Re: Mayor's Office of Emergency Management
7 World Trade Center
Change Order #044
Amb. Job #S57-5175

Furnish and install the fuel oil piping in accordance with Swanke Hayden Connell sketch dated 12/14/98 revise routing. The following are the costs:

1 PART PLAN RM# 23-09
1/8" = 1'-0"

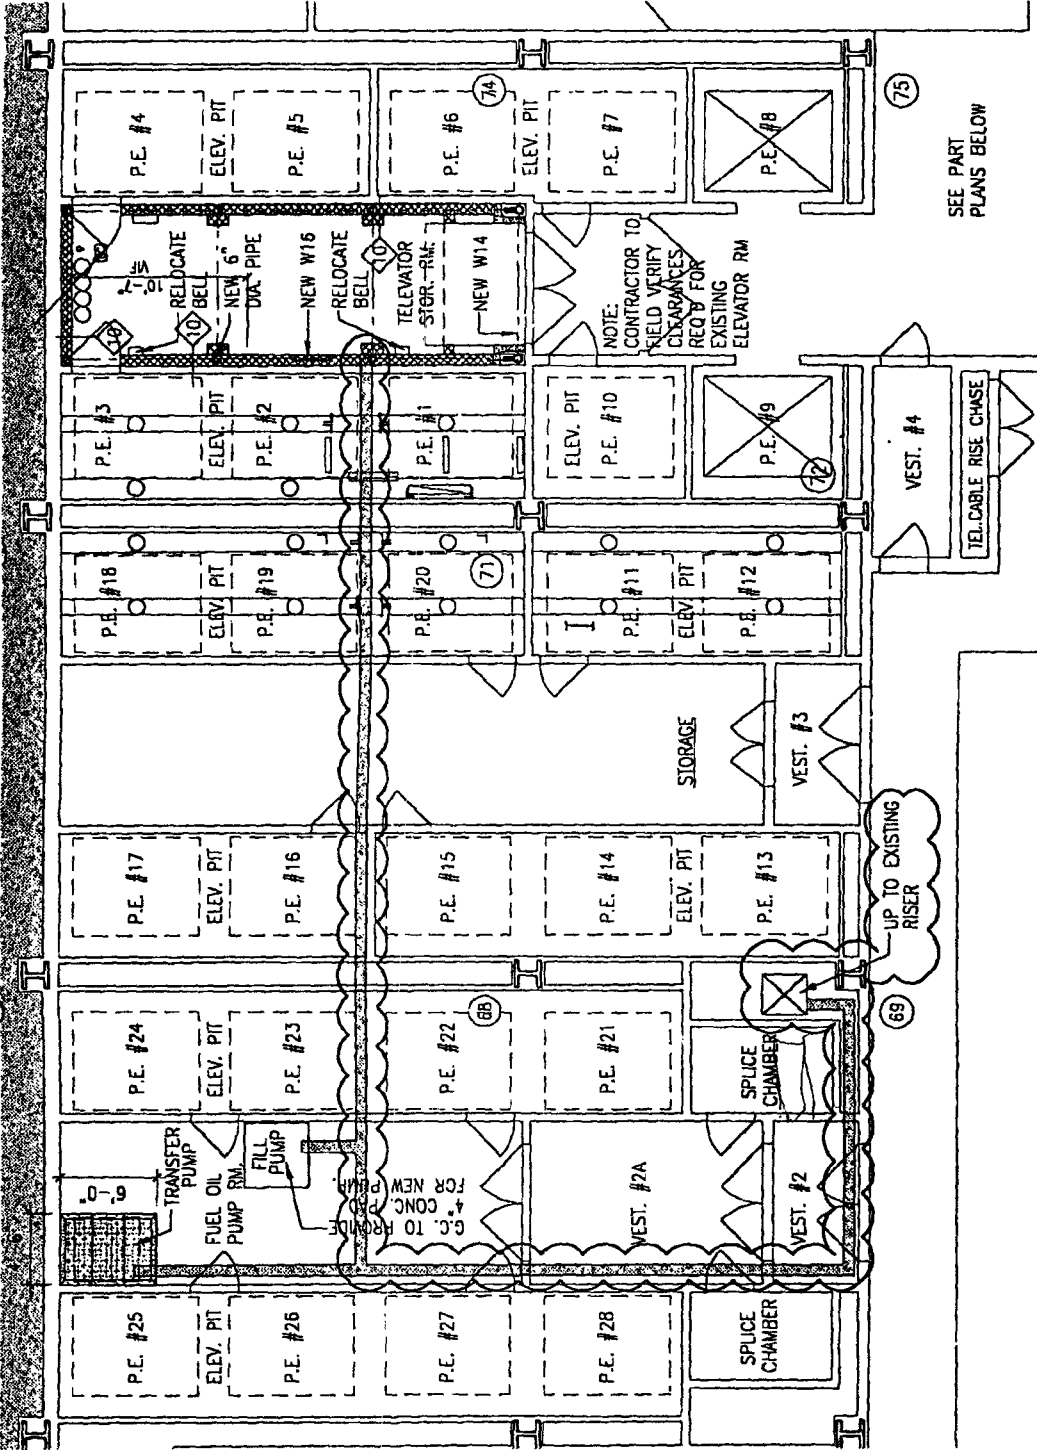
- Furnish and install 2 hour rated enclosure of lath with two (2) inches of plaster around pipes suspended box.	\$15,470.00
- Remove and replace sheetrock ceilings	✓ \$2,500.00
- Paint ceiling	✓ \$1,500.00
- Patch block	✓ \$1,500.00
Subtotal	\$20,970.00
General Conditions	1,678.00
Overhead and Fee	1,359.00
Insurance	300.00
Total	\$24,307.00

1. COORDINATE, FIELD VERIFY ROUTE OF PIPING THROUGH PIT AREA
2. COORDINATE, FINAL LOCATION W/ ALL EXIST. STEEL

3. ALL PIPING TO BE IN 6" DAL CONDUIT & ENCLOSED IN A 2HR. FIRE RATING THROUGHOUT. ALL PIPES WILL BE 10'-0" AFF TO BOT. MIN.
